3.8 Pre-application 2 - 10th January 2019

The same scheme that was presented at the public exhibition was presented to the London Borough of Richmond upon thames to ensure feedback was based on the same proposals. No formal feedback has been received to date so the following comments have been collated from the design team minutes from the meeting.

3.9 Councillor meeting - 11th January 2019

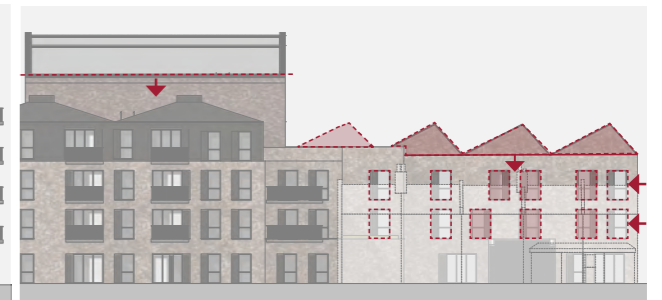
Crane Road residents' privacy and aspect

- Some residents who live towards the northern end of Crane Road were concerned about potentially being overlooked by new residents
- There was also concern over the height of the proposed apartment buildings and the impact that would have on their views and aspect

The following amendments were subsequently made to the proposals to address concerns about overlooking and aspect:

- The saw-tooth roof along the western edge (backing onto Crane road gardens) was removed and the eastern edge reduced
- The size and number of windows overlooking Crane Road gardens from apartment buildings were reduced in size or removed altogether where possible
- The accessible area of roof terraces were set back from the roof edge to avoid overlooking
- Floor to floor heights were reduced to minimise the overall building height
- Existing boundary factory walls where on the red-line boundary have been retained where structurally possible to maintain existing condition for neighbours
- Look at improving privacy further by introducing a trellis to boundary walls

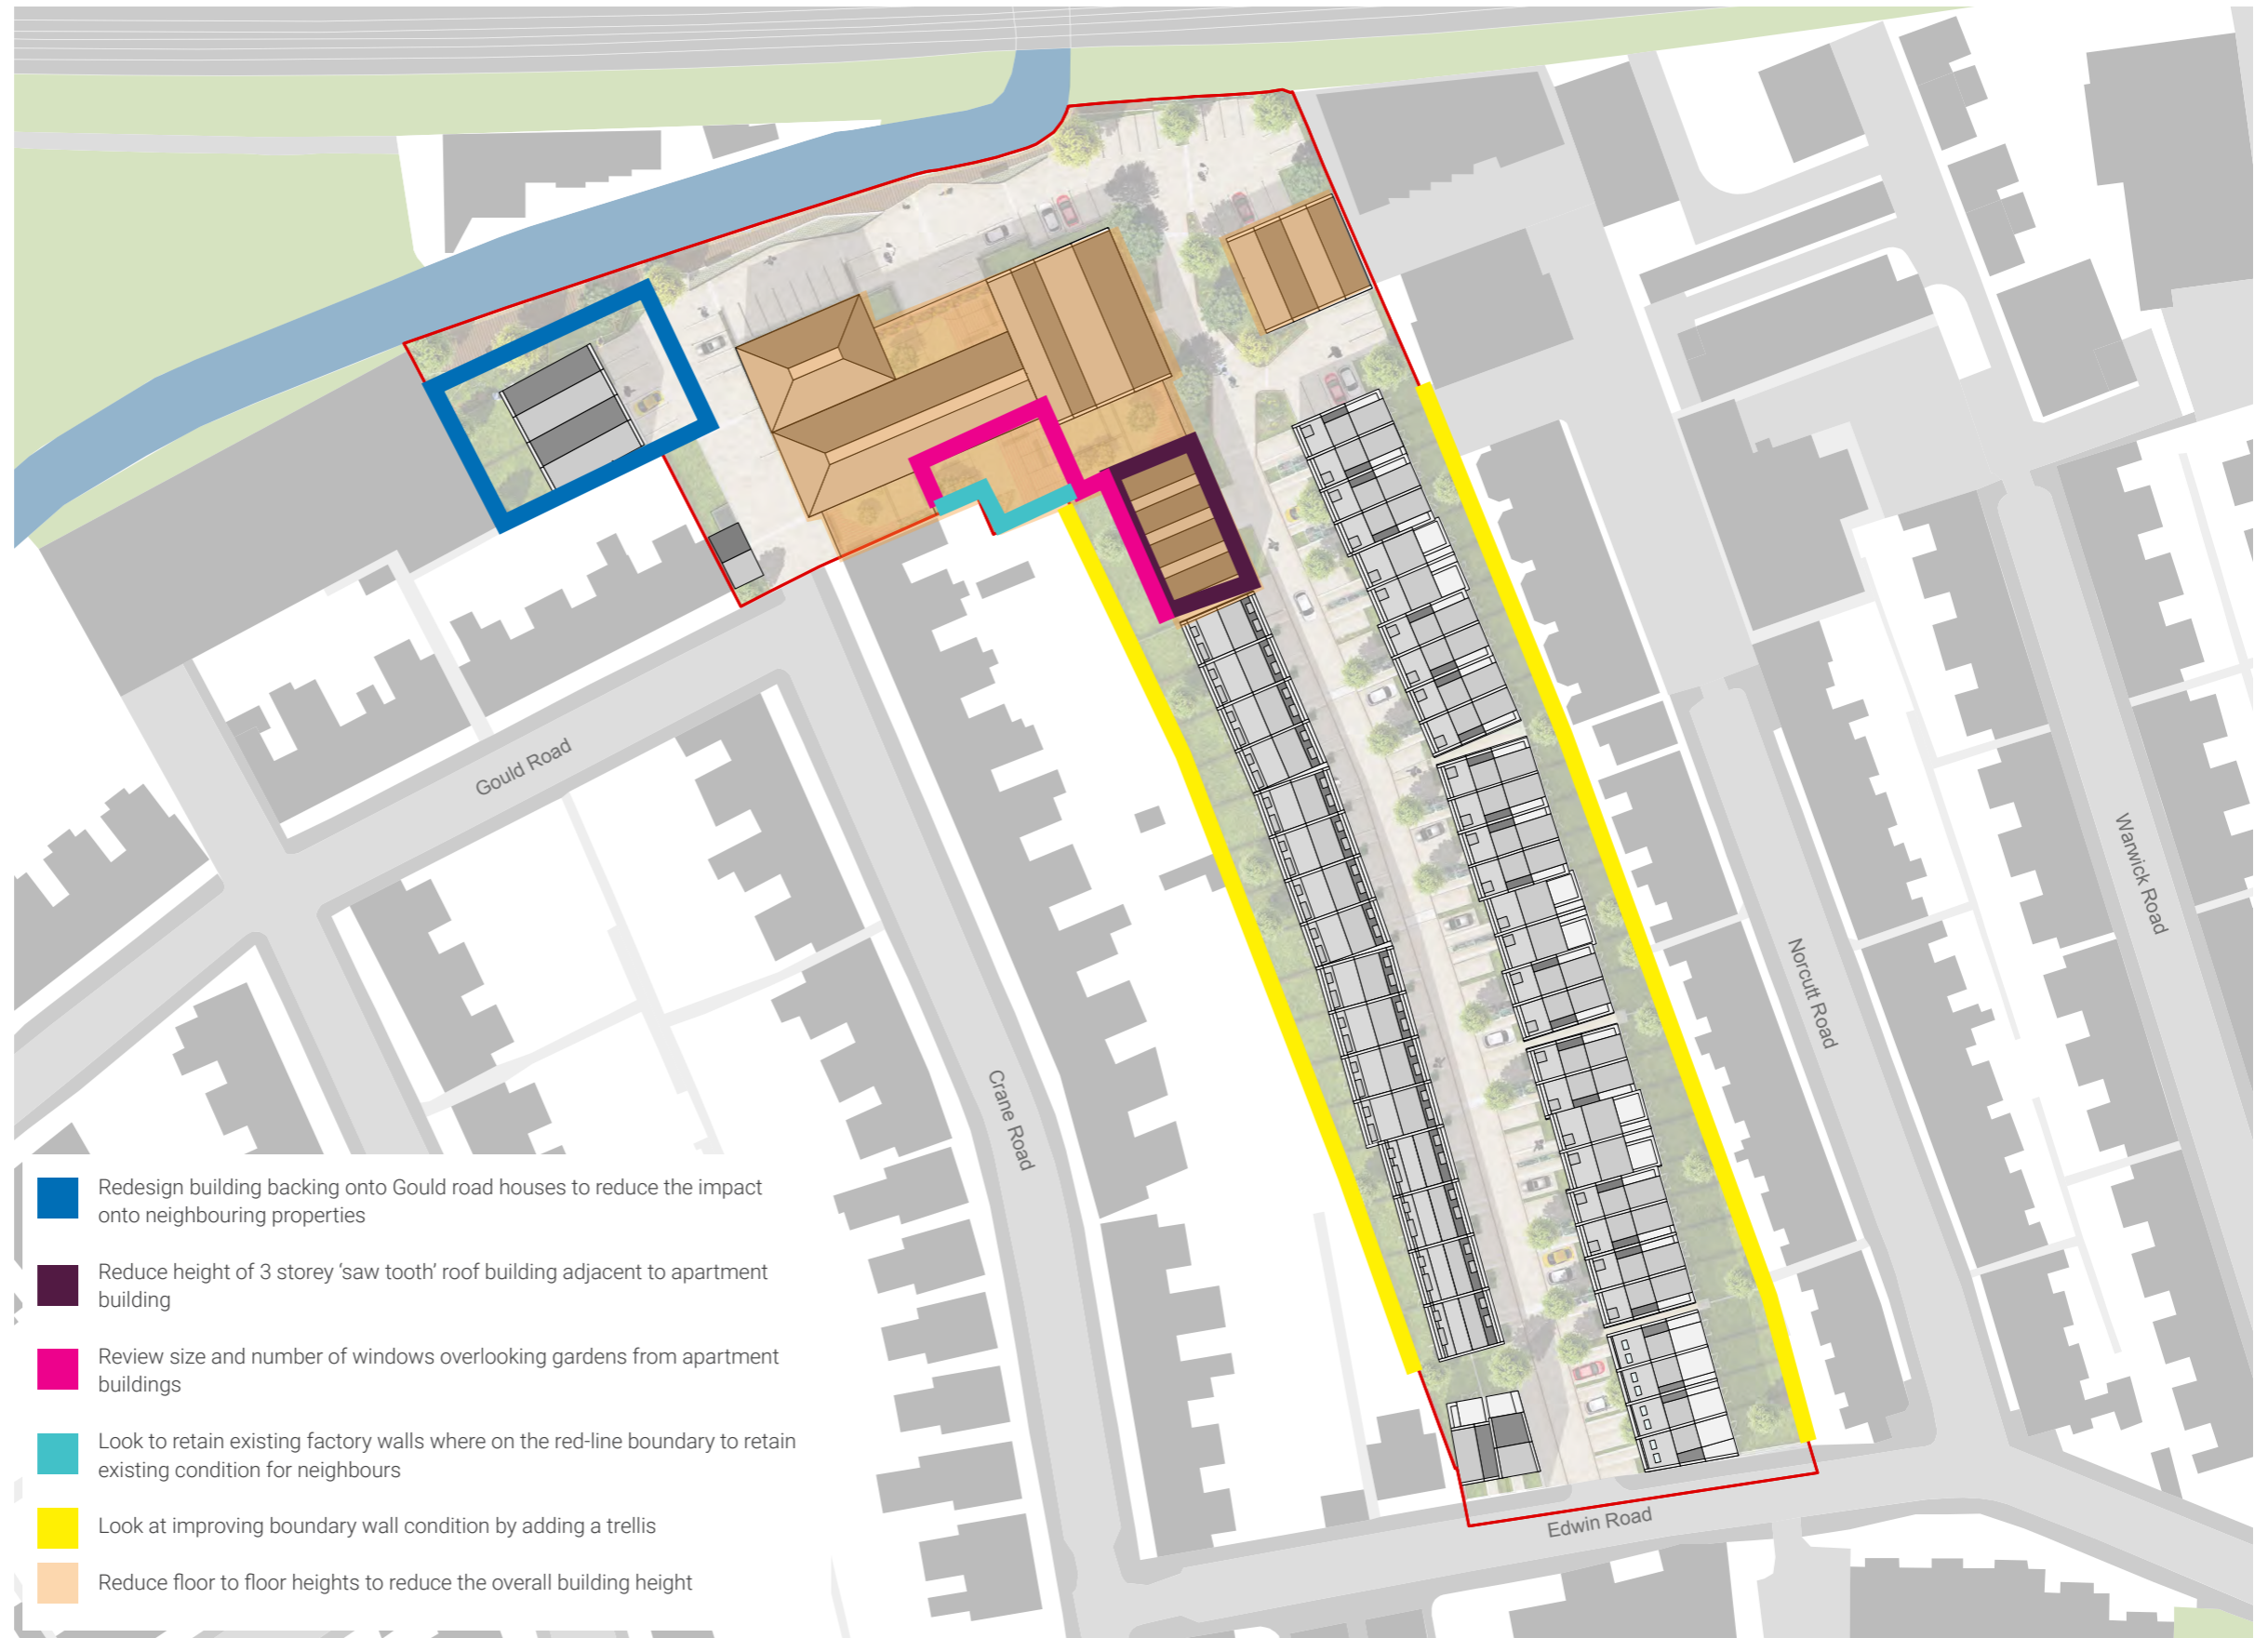
Gould Road residents' privacy and aspect

- Residents who live towards the eastern end of Gould Road were concerned about potentially being overlooked by new residents
- There was also concern over the proximity of the proposed apartment building backing onto their gardens and loss of views, light and overshadowing

This small apartment building was designed to change the configuration to directly address these concerns.

- The building footprint was moved off the site boundary edge with back-to-back gardens similar to the condition elsewhere in the area
- The massing of the proposals was considerably reduced so that it is now just one storey adjacent to the boundary, stepping up to two storeys as you move further away
- The proposal accommodates accommodation in the first floor roof, and has no additional massing, effectively losing an entire floor
- A low pitch ensures no overlooking towards adjoining houses and only views northwards from first floor or towards the sky through the rooflights

Revised ground floor including commercial building

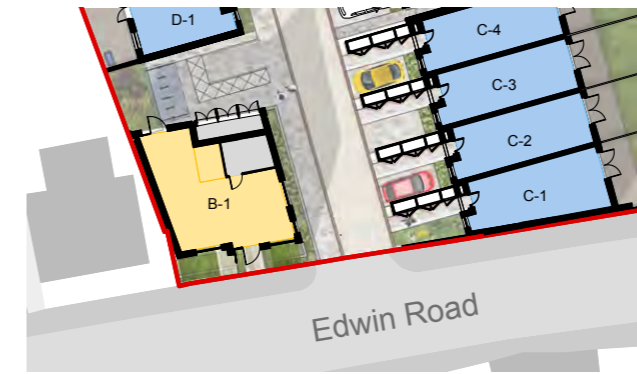
Land use

- The officer noted that residential use is a deviation from policy, however the team responded that industrial is inappropriate for the site due to its residential location. As such, the officer confirmed that B1 commercial use could be considered
- Encouragement for family houses not withstanding policy considerations

- The two houses fronting Edwin Road were removed and a new commercial building proposed in its place. This resulted in 116 residential units (47 houses and 69 apartments), and a B1 use Commercial unit that will be SME.
